Float Incorporated Response to Airport Authority Letter Dated 8-21-03

This is Float Inc.'s response to a letter from the Airport Authority dated August 21, 2003. That letter was a response to the resubmission of the material requested by the JAAC on October 22, 2002. These materials were hand delivered to the ATAP on November 12, 2002, but apparently misplaced and not considered in the preparation of the Tier 1 report. The Airport Authority's August 21 response is in italics.

Regional Airport/Harbor Proposed For The City of San Diego

Comments to Working Group 8-26-03 on Offshore Floating Airport

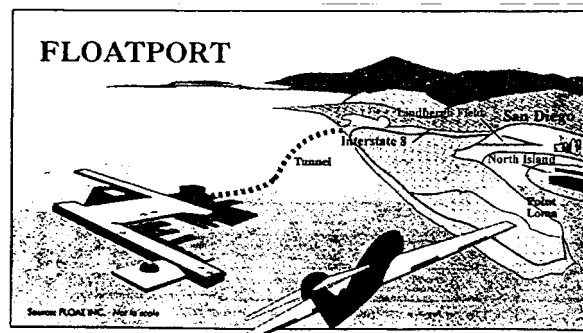
- *Float Incorporated proposes a submerged floating set of tunnels (tethered to the ocean floor) as the primary access. This concept has been rejected as a feasible technology for a similar application (Lake Washington, Seattle, WA estimated \$3 billion for a two mile length through shallow and calmer water) and cannot be considered in lieu of conventional causeway*

technology given FloatPort's very low \$540 M estimate for a 4.5 mile tunnel plus a 0.75 mile transitional tunnel which appears to have remained the same since the report was published in 1995. A causeway would be no more financially unfeasible or environmentally unacceptable than a submerged "floating" tunnel. The feasibility and cost estimate of the tunnel access was suspect and questions regarding the cost estimate were raised in earlier correspondence, however, the same unmodified data was provided in response. A causeway extending Interstate 8 was deemed the most appropriate approach.

The 3 billion dollar estimate cited here for Seattle is actually a 2.5 to 3 billion estimate for a "submerged sunken" tunnel. The estimate for the floating version is 1.5 to 2.5 billion dollars. Thus the floating tunnel is estimated to cost approximately 70% as much as a sunken tunnel. Conventional causeway technology was not considered, as the lake is too deep. In the absence of water traffic, tides and waves, a floating (on concrete pontoons) bridge would likely be the most cost effective solution. This is bolstered by the fact that two floating bridges presently carry traffic across the lake. Weather, traffic and waves dictate that the tunnel floats submerged, out of those influences.

Who deemed the causeway to be the most appropriate approach? A causeway was specifically rejected by Float because the ocean depth at the proposed location of FloatPort is 320 feet. Whether constructed on fill or pilings, it would be prohibitively expensive, a navigation hazard and an environmental nightmare.

Float's estimate was carefully worked out last November, and the detail provided, using inflation-adjusted numbers. By way of comparison, the cost of the recently completed, sunken tunnel between Denmark and Oresund, Sweden was 483.5 million for 3.5 kilometers. It is not valid to assume a linear cost per mile comparison, longer tunnels should cost less per mile, but even ignoring that, using the 30% reduction for floating, and considering that the Oresund tunnel has two land transitions, the 540M estimate is reasonable.

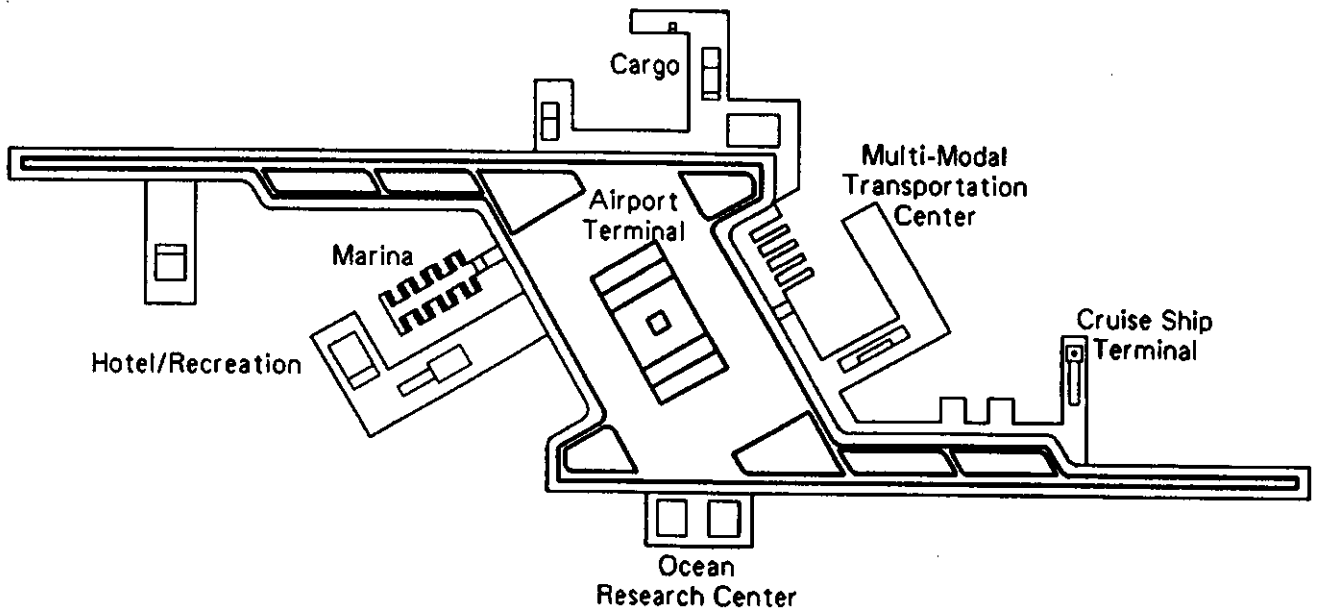
- *Floatport's assertion that the location off of Mission Bay evaluated in Tier 1 is different than the location off of the southern tip of Point Loma is inconsistent with its own Figure 1, in the paper entitled FLOATPORT: "A floating solution to the San Diego Airport's Environmental Problems" MTS Journal, Vol.29, No.1) depicting the conceptual facility located south west of Mission Bay. Locating the facility off of the southern tip of Point Loma would require all airport-bound traffic to traverse through the peninsula beneath Cabrillo National Monument to a tunnel entrance located in one of the best known wildlife preserves in the State.*

Nowhere in the text or graphics of any of the materials submitted with this proposal, nor on Float, Inc.'s web site is the airport depicted or described as floating off Mission Bay or being accessed from Point Loma. The Figure 1 referred to is a perspective cartoon drawing by an artist working for the magazine and is labeled "Not to Scale". Further, the text, immediately above the figure describes the location as "three miles West of the Southern tip of Point Loma". Obviously the tunnel never approaches within three miles of the Cabrillo National Monument.
